Houston-Galveston Area Council

Re: 2045 Regional Transportation Plan Amendments

Dear H-GAC- Planning and Projects Committees,

### Concept A

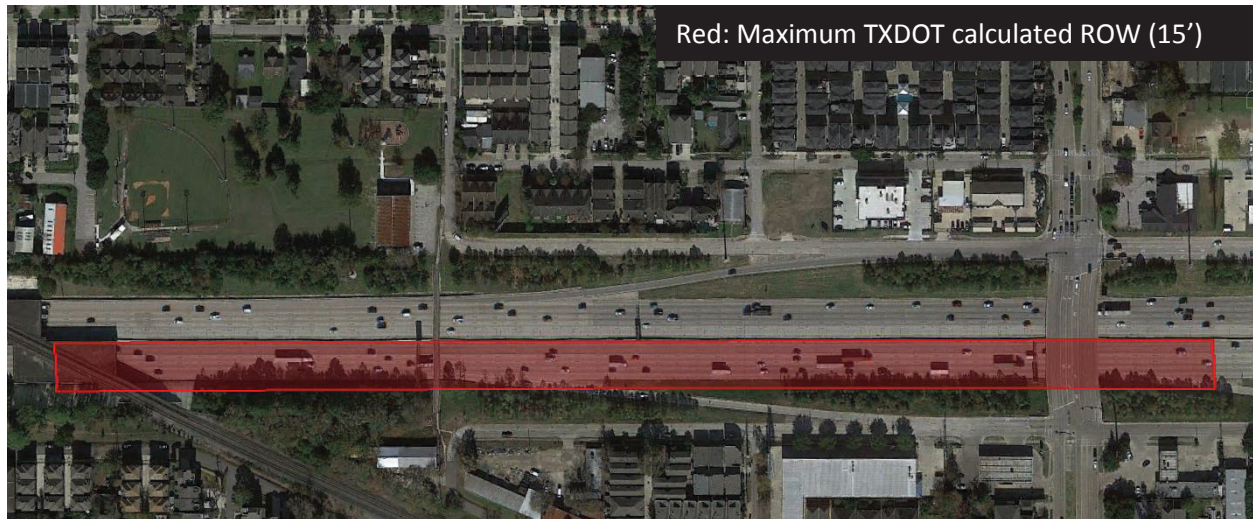
Today, Cottage Grove is separated from I-10 with an approximately 75-foot wide green space buffer. This buffer is populated by dense tall trees which reduce freeway sound and allow residents at Cottage Grove Park to enjoy a view of nature.

The potential right of way acquisition associated with Concept A is the largest concern of the residents. Concept A appears to, at a minimum, remove this green buffer and bring the neighborhood in direct contact with I-10. If the full right of way is utilized (115 feet) then it appears that Cottage Grove Park and even some homes will be consumed by the project. TxDOT sound barriers have questionable effectiveness and with the threat of losing our precious greenspace, we strongly oppose this concept.

**Alternative 1**

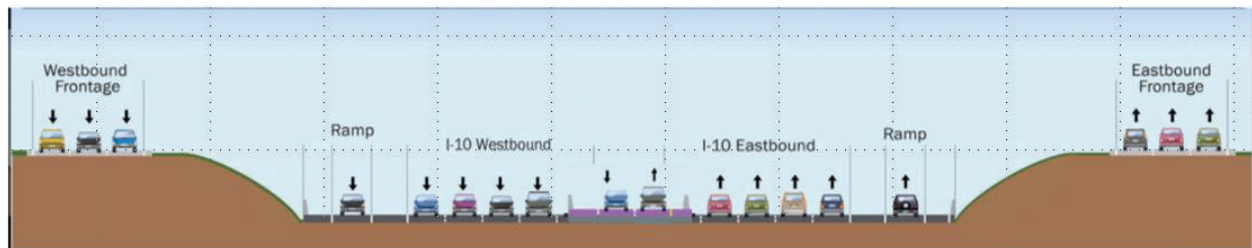
**Alternative 1:** Convert existing main lanes into managed lanes.

TxDOT's stated purpose is to improve multimodal mobility and reduce reliance on single occupancy vehicles. By converting two main lanes TxDOT would demonstrate its commitment to this goal. Commuters would be incentivized to utilize these lanes by either riding with additional passengers or taking public transit. This would substantially increase the number of people/hour the lane is able to serve and accomplish all of TxDOT's goals.

TxDOT Concerns: The higher capacity of the managed lanes is dependent on travelers switching to alternative forms of transit than single occupancy vehicles.

- This is the stated purpose of the project and TxDOT's response is unclear.

**Alternative 2**

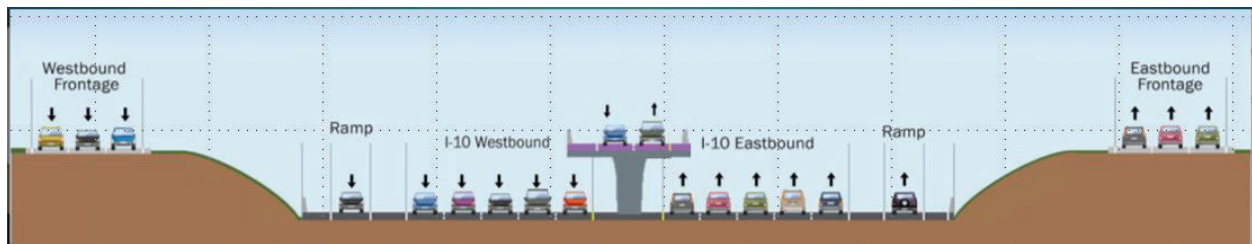
**Alternative 2:** Install two elevated managed lanes in the center of I-10.

This alternative improves on Alternative 1 by leaving the main lanes unchanged but adds the additional capacity in a manner that minimizes impact to the neighborhoods. Central 2-Lane managed lanes are already installed on several freeways around Houston.

TxDOT Concerns: A single managed lane in each direction has the potential for vehicles to breakdown or have accidents and stop the flow of traffic.

- A semi-truck is 8.5 feet wide. TxDOT should explore elevated structures capable of supporting the two lanes with necessary shoulder requirements. If support columns exceed the available space in the current 20 foot wide median then a single managed lane with alternating directions should be considered.
